**Addendum 1**

**Bid No. 23-010-2023-PW-008F**

**New Volanta Baseball Field Fencing**

# DUGOUT DETAIL

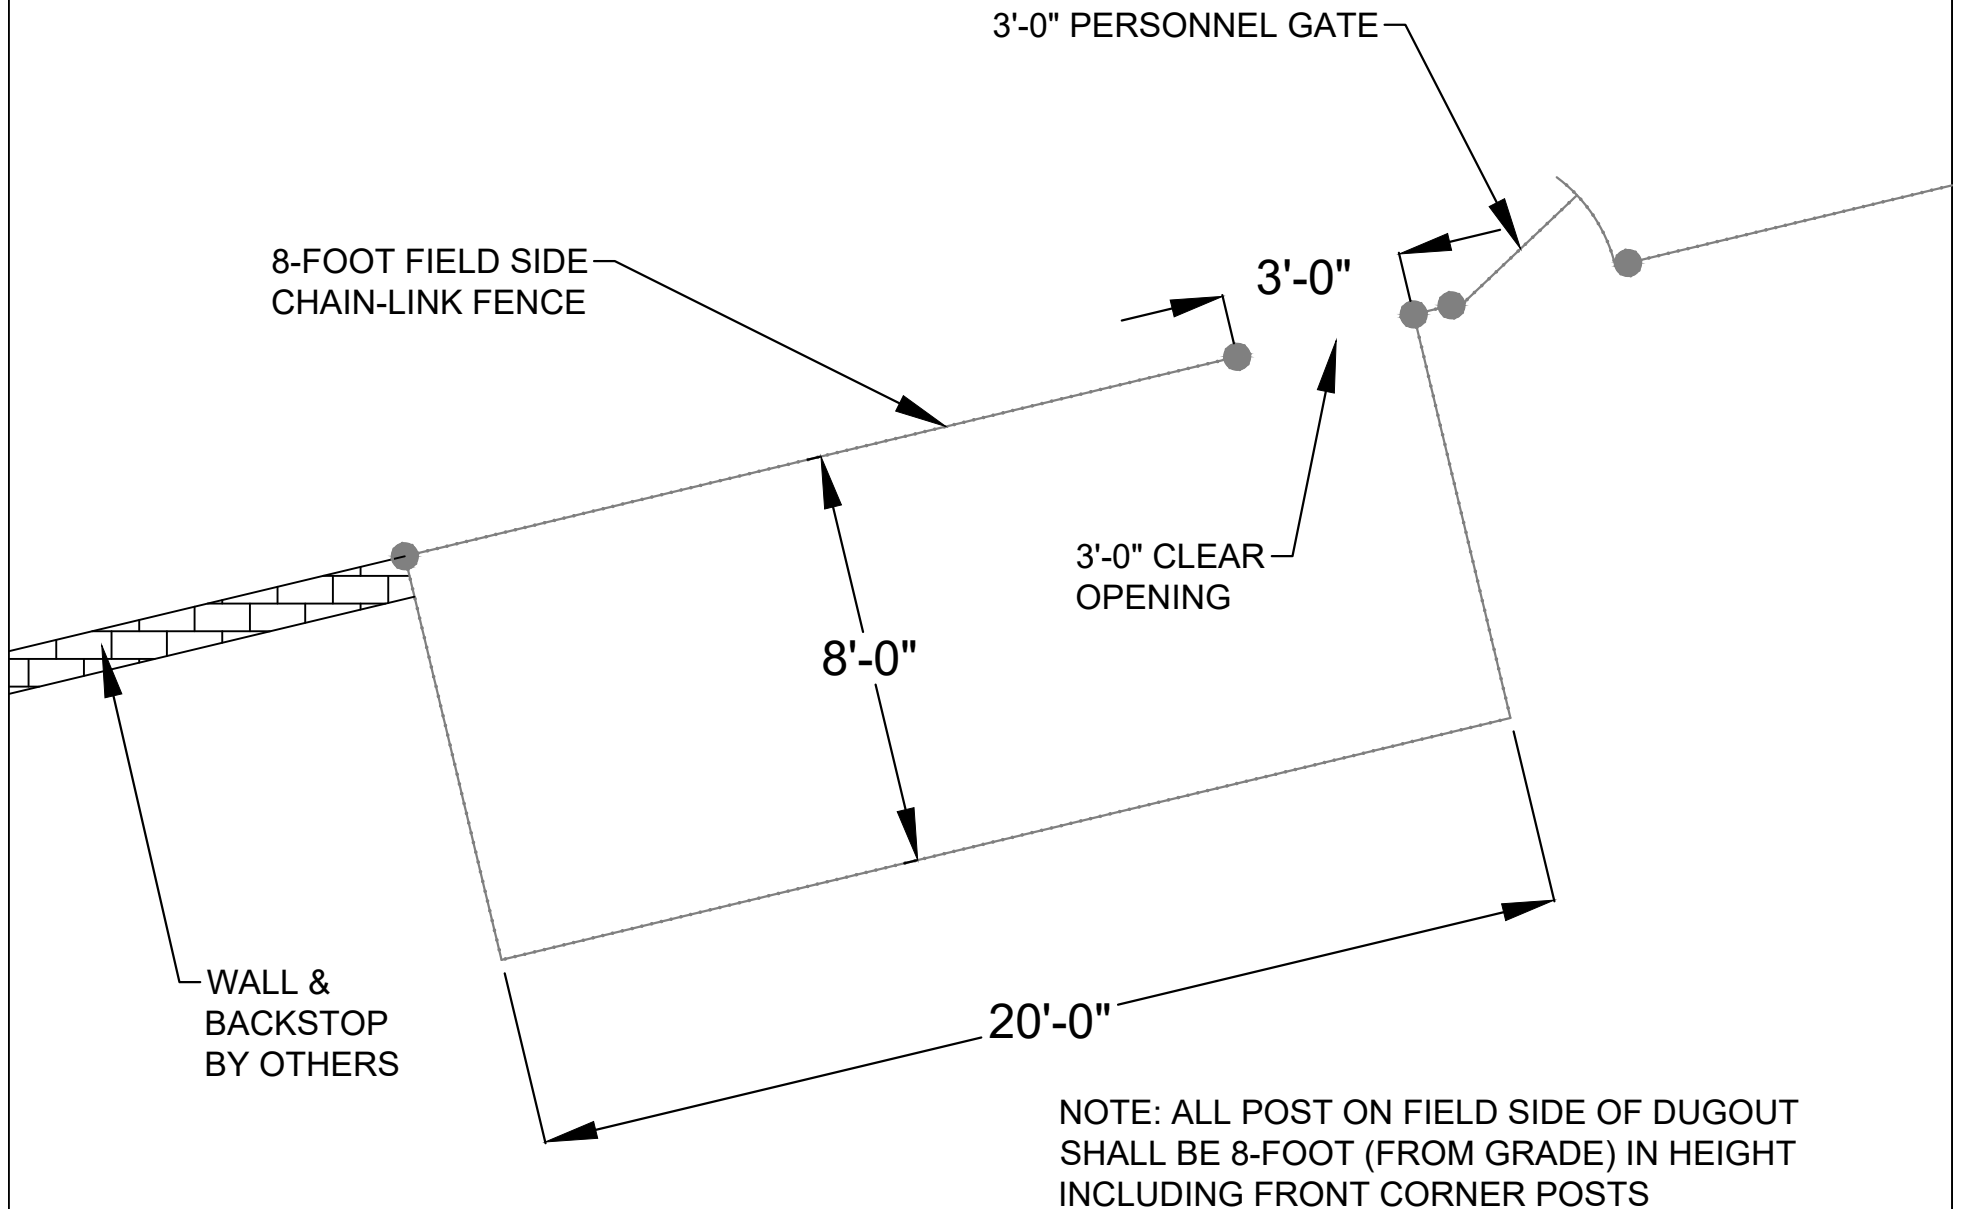
Fence Height at Dugouts - The front (20-foot field side) of all dugouts shall have a chain link fence height of eight (8) feet above grade. This shall include a fence post height of eight (8) feet for the entire length, including the two front corner post. The total linear feet of 8-foot fencing is 160 L.F. (less the 3-foot clear opening for each dugout on the field side). No mid-rail shall be required in this fence section. See attached detail.
